Central Planning Authority

Agenda for a meeting of the Central Planning Authority to be held on **May 24, 2023 at 10:00am in Conference Room 1038, 1st Floor, Government Administration Building, and Elgin Avenue.**

CPA/12/23

Figure 2: The aerial imagery of the site showing the application site (outlined in red) (Source: LIS, 2018).

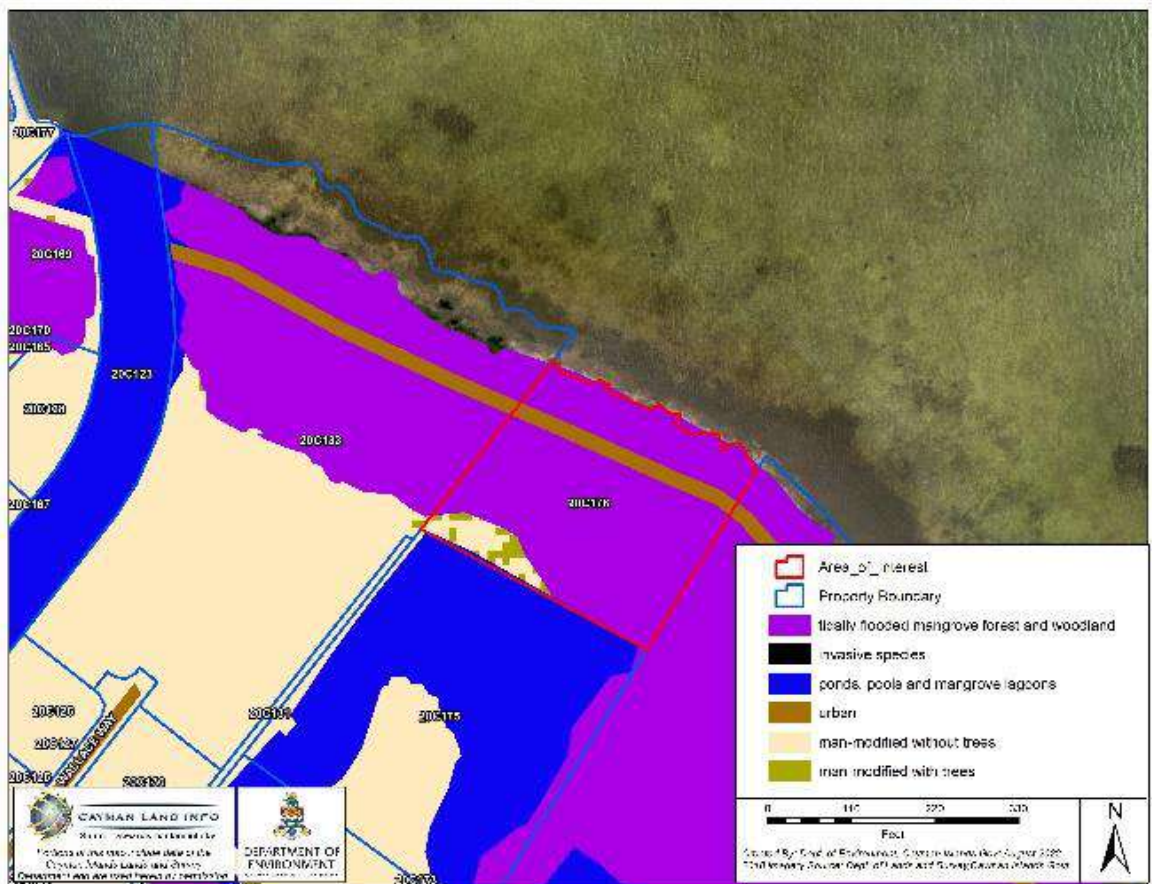
The application site consists of primary tidally flooded mangroves and secondary growth and incorporates part of the Mangrove Buffer Zone as shown in Figure 1.

Figure 2 shows the site proposed to be excavated as part of this planning application. Figure 3 shows the habitat at the site.

It is noted from the cover letter that the application is submitted in the interest of Greta's Grotto Senior Living Facility. The stated purpose of the facility is to obtain large quantities of fill for a proposed development site in West Bay (Block 8A Parcel 86 and 96). The proposed source of fill/navigational channel is the subject of a Coastal Works Permit application which has not yet been determined by Cabinet. There are no plans presented for any future development that would use the navigational channel and inland canal. The planning application does not contain any commercial development such as a marina, dock or commercial buildings etc. The proposed haul road is described as only temporary and there is no space for a commercial development on this parcel as the site is either Mangrove Buffer Zone or already excavated to form an inland pond. Therefore, it seems likely that any future development would require either filling in part of the lake, developing within Mangrove Buffer Zone (contrary to its purpose) or the purchase/lease of adjacent properties.

Figure 4: LIS 2018 showing an example of an alternative canal route in purple to link the lake to North Sound for boating access while preserving the mangrove buffer.

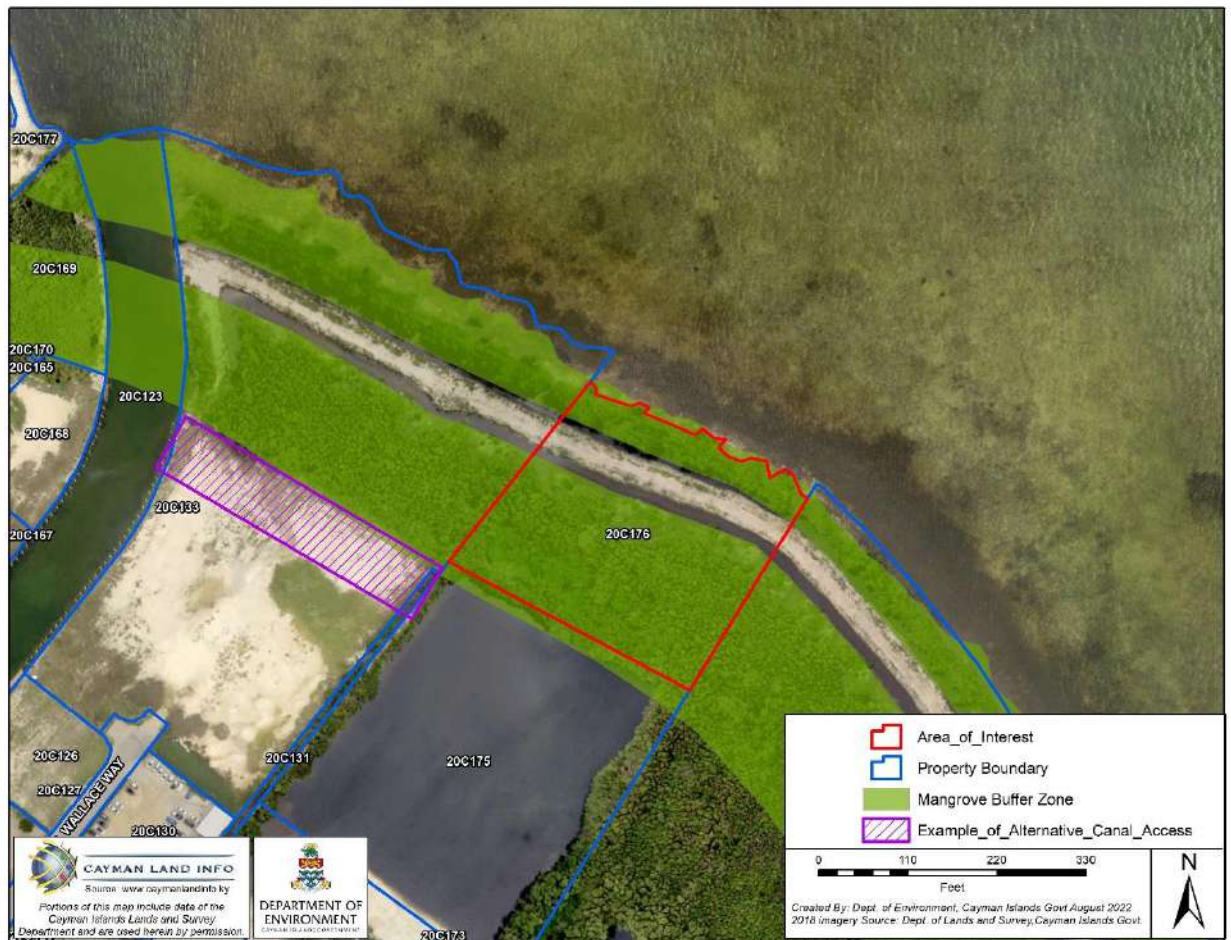
Given that there is no development being proposed on the site, just the canal to an inland lake, it does not seem absolutely necessary to gain safe boating access to an area with no development. There is a safe alternative for boating access from the parcel to the west at Block 20C Parcel 123. The applicant can negotiate access across Block 20C Parcel 133 and create an inland canal, which does not require going through the Mangrove Buffer Zone (Figure 4). This will allow the mangrove buffer to continue to provide ecological services and benefits including storm protection.

In addition to the loss of mangroves and their ecological services, the Department also has concerns about connecting the existing lake to the North Sound. When the connection is made between the existing excavated pond and the North Sound, there will be water quality impacts from the mixing of the stagnant water in the existing excavation with the water in the North Sound. The depth of the water in the inland pond, which was excavated around 2008, is unknown, and is not depicted on the application or the drawings. Any fine settled material on the bottom of the lake is likely preventing the reestablishment of marine growth and may cause fish kills and algal blooms. The canal will then be connected to the North Sound impacting those sensitive marine resources. There may be continual resuspension events and/or a long-term impact.

Figure 1: Topography of South Sound drainage basin (outlined in red) and location of proposed road (outlined in yellow)

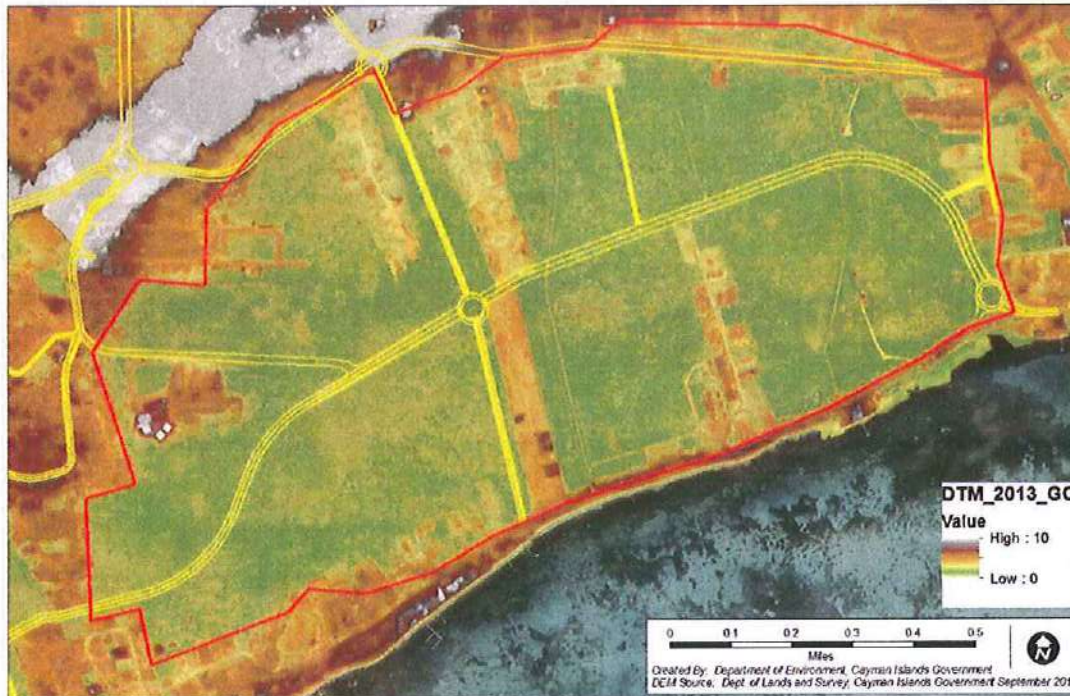
Proposed and existing developments including new roads in the South Sound drainage basin are shown in Figure 1 and Figure 2.

Unless the drainage and flooding issues in the area are addressed in a comprehensive manner, prior to these developments and the road coming forward, the agencies have grave concerns regarding the impacts of seasonal flooding on existing developments and on the quality of the receiving waters; i.e., the South Sound lagoon.

Figure 2: Aerial image showing permitted developments (highlighted in red) and proposed developments (highlighted in blue) within the South Sound drainage basin.

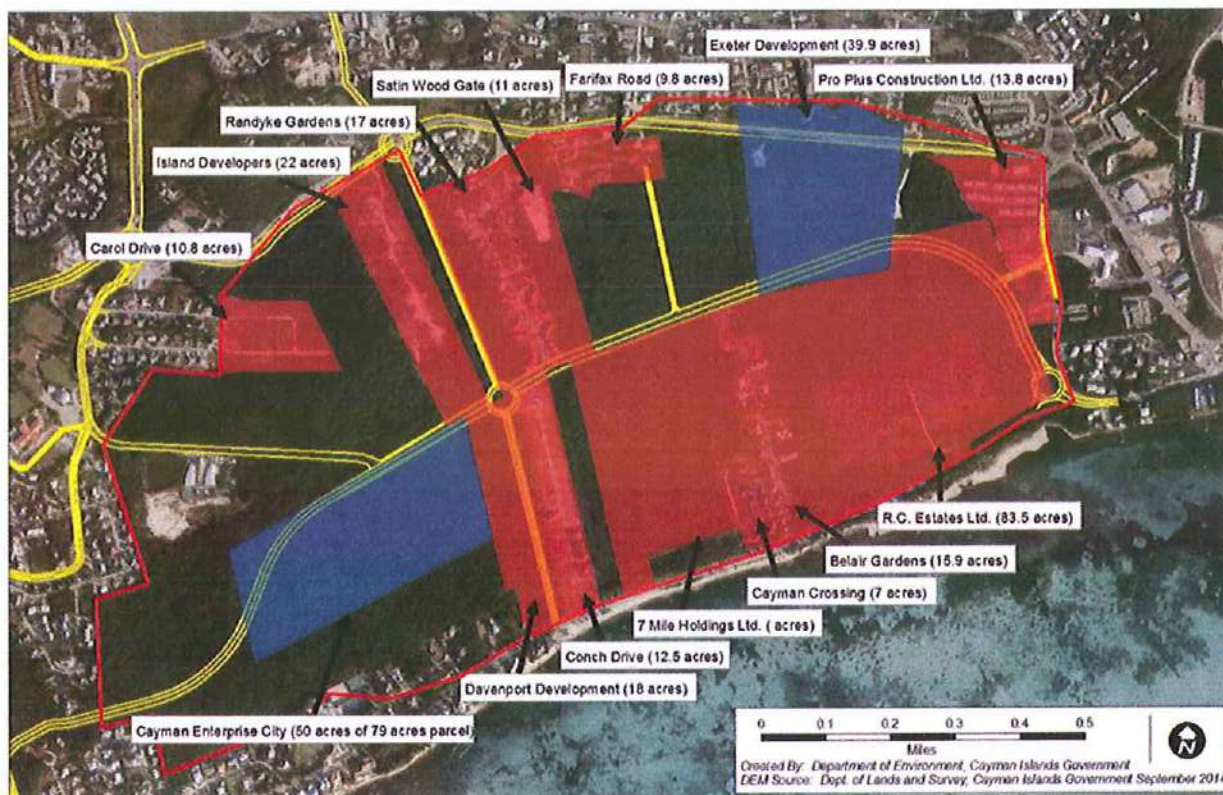
A number of existing developments in the basin become inundated with rainwater during the wet season; most notably Randyke Gardens. Several new residential subdivisions have been granted CPA approval in the past 3 years and, most recently, the agencies have been contacted by Cayman Enterprise City regarding a 50 acre development in the basin and an application has been received from Exeter Development Ltd for a 30-35 acre general commercial development to the south of Linford Pearson highway (comprising a large anchor grocery/retail outlet, with supporting ancillary retail and commercial development); see Figure 2.

The South Sound mangrove basin is a blocked non-tidal mangrove wetland which is impounded by the beach ridge and South Sound road to the south, and higher elevation, drier land as well as the Linford Pearson highway to the north. The beach ridge and roads are relatively impermeable to sea water and the mangrove swamp is flooded principally by rainwater. Historically, excess rainwater not retained by the extensive mangrove wetland basin gradually percolated through the beach ridge and mangrove coastlines along the length of South Sound lagoon. Following the construction of South Sound Road and the beginning of developments which reclaimed portions of the mangrove wetland, a series of MRCU physical control canals installed in the 1970's helped to alleviate storm waters and, more recently, a series of culverts were installed by PWD/NRA under South Sound road to drain the mangrove basin to the South Sound lagoon. However, the recent filling along the eastern end of the shoreline in South Sound has resulted in many of these culverts being blocked. The one remaining culvert, in close proximity to the Red Bay dock, is normally blocked by the NRA with a sheet of metal placed in front of the culvert; this culvert is made operational when required (see figures 3 & 4). Seasonal flooding of Randyke Gardens and other low-lying developments in the basin has become a normal occurrence and without a regional stormwater management plan, this flooding will get worse.
